5 December 2024  
PJ024-1440-L02

Subject: Responses to Questions from the Planning and Zoning Commission -- Acoustics

Reference: #2024-0257 / Wake Robin LLC & Ms. Serena Granbery  
(ARADEV LLC) / 104 & 106 Sharon Road & 53 Wells Hill Road /  
Special Permit for Hotel (Section 213.5) / Map 47 / Lot 2 & 2-1 / DOR: 08/05/2024

**BARRIER ATTENUATION CALCULATION**

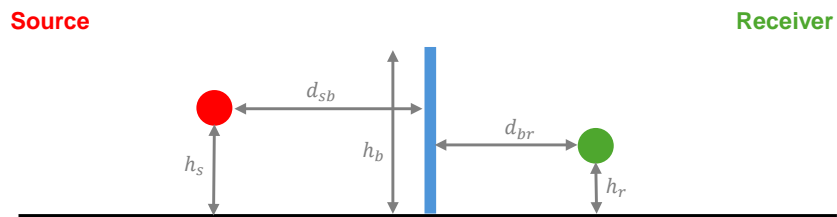
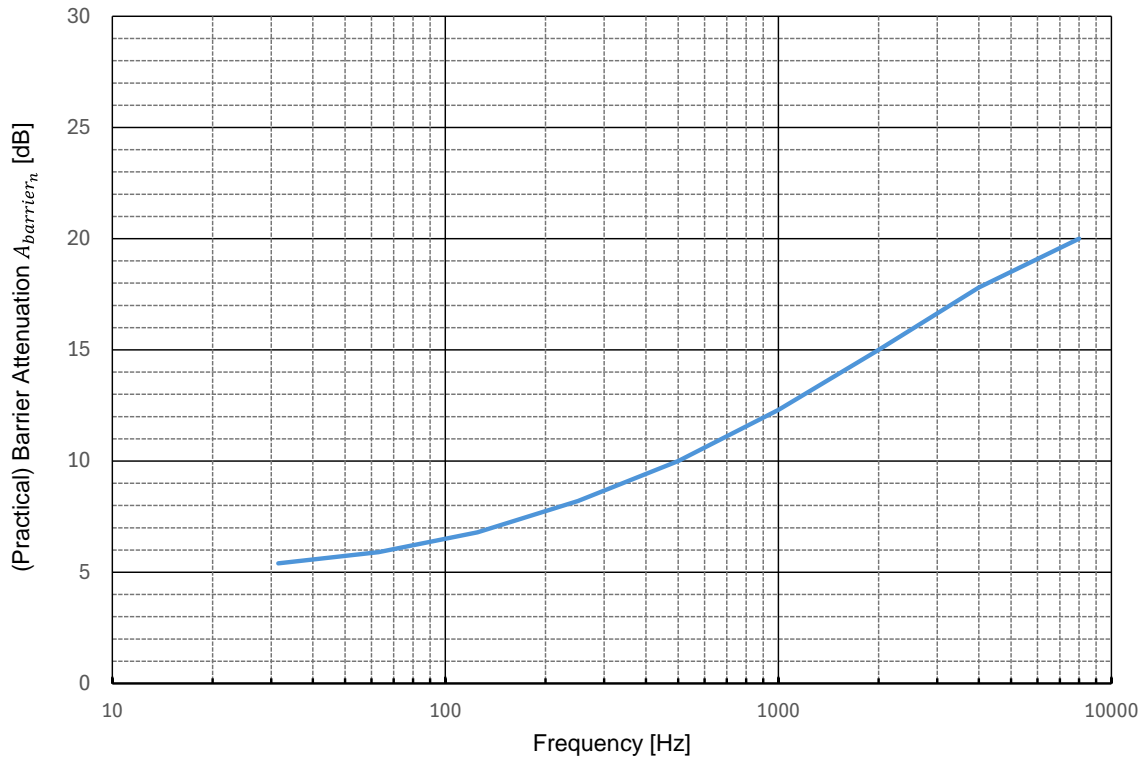
A3. A heavy (masonry or fabricated noise barrier) wall 8 ft high will provide a moderate reduction of about 13 dBA. Please see the attached calculations and the discussion below. This places the vehicle noise emissions still well above CT State noise limits. Other areas which may benefit include the "Cottages" and any other facility near the neighbors. It is cautioned that this sound barrier wall must be substantial and very heavy, such as masonry or a fabricated wall at least 5 pounds per square foot face weight, with no gaps or leaks.

The effect of a *noise barrier wall* on property line near NW parking lot was calculated. Note that in order to be an effective sound barrier, the wall would need to be solid and heavy – masonry or fabricated wall (at least 5 pounds per face square foot) along the entire property line near parking lots/residences.

**BARRIER ATTENUATION CALCULATION**

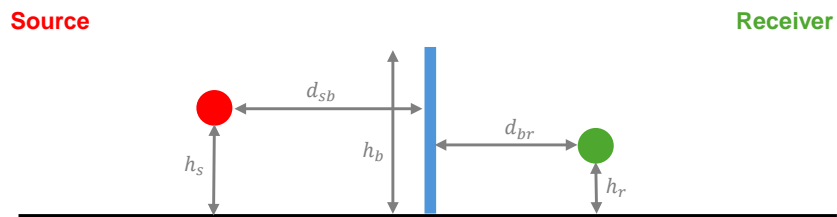
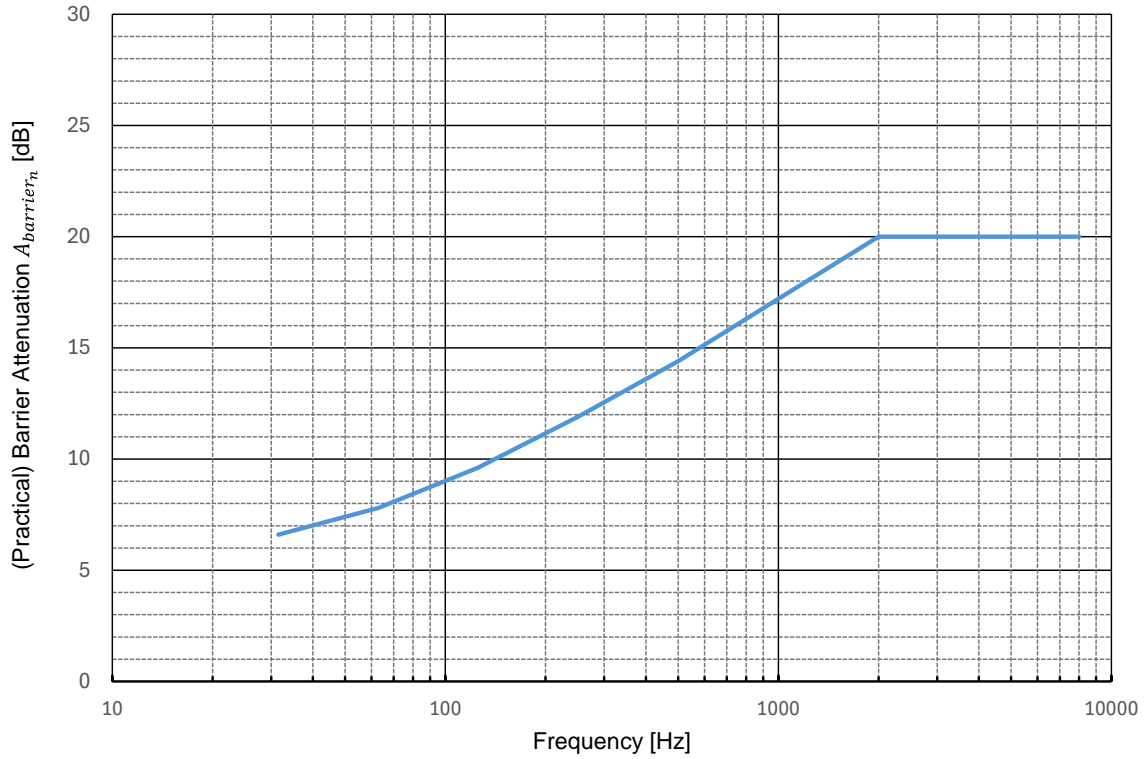
Note also that there are *diminishing improvements* with a higher wall (12 feet) compared to the zoning reg wall max of 8 ft. Building the wall higher at 12 feet yields only about 4 dBA improvement (reduction of noise) which is barely noticeable, compared with the 8 foot high wall.
